# Shute Memorial Library

## City of Everett ADA Transition Plan

July 2018

### Shute Memorial Library

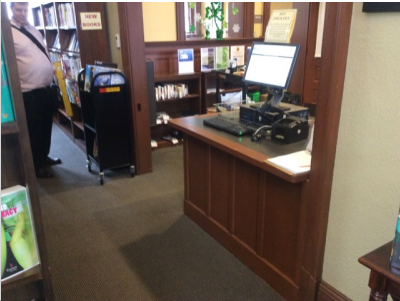
9	Children's Librarian Room	1	019	Doors, Doorways, & Gates	Office		Maneuvering clearance(s) not provided	-	Relocate cart.	1	Labor	\$0
